Application Number: 10/729,183
Filing Date: December 04, 2003
Appellant(s): MILES, MARSHALL

EXAMINER'S ANSWER

This is in response to the appeal brief filed November 26, 2008 appealing from the Office action mailed February 8, 2008.

2. Claims 1-9 are rejected under 35 U.S.C. 102 (a) as being clearly anticipated by Youn et al. (USP 6,459,604). See figures 2 and 3 (below). See also the abstract.

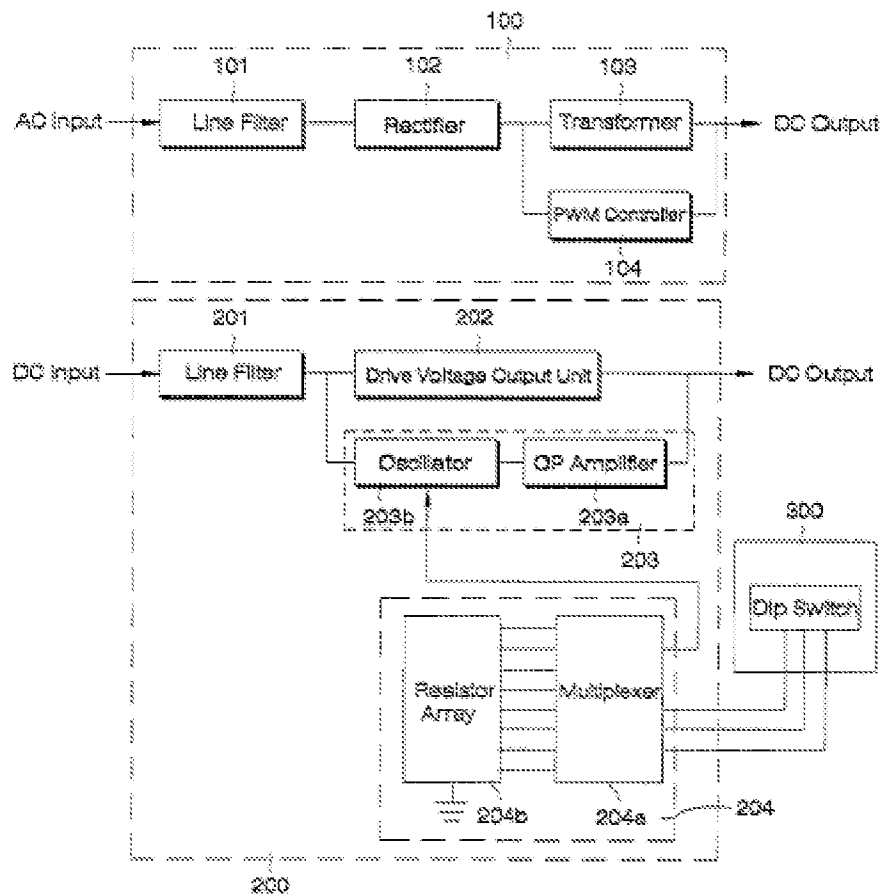
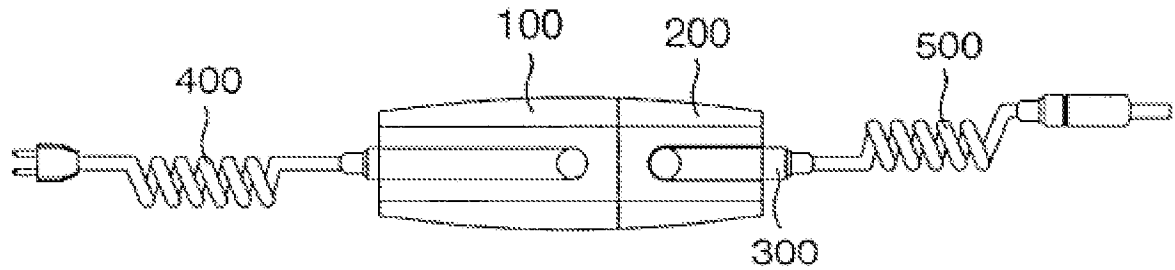
Applicant's claim 1 copied below with the prior art (Youn et al.) equivalent in parenthesis (See above figures):

(Original) A power adapter comprising:

a first housing (100) ;

a second housing (200) remote from the first housing (100);

an AC input receptacle (arrow into 101) provided in the first housing (100);

a voltage converting circuit (rectifier 102) enclosed within the first housing (100) and electrically connected to the AC input receptacle (arrow into 101), the voltage converting circuit (rectifier 102) converting input AC power into a DC voltage; and a voltage regulating circuit (drive voltage output unit 202) electrically connectable to the voltage converting circuit (rectifier 102) and enclosed within the second housing (200), the voltage regulating circuit (drive voltage output unit 202) maintaining and outputting the DC voltage from the voltage converting circuit.

As can be seen above the Youn reference discloses the claimed invention. The claim language is not distinct from that of the prior art. Appellant argues that "only a few components
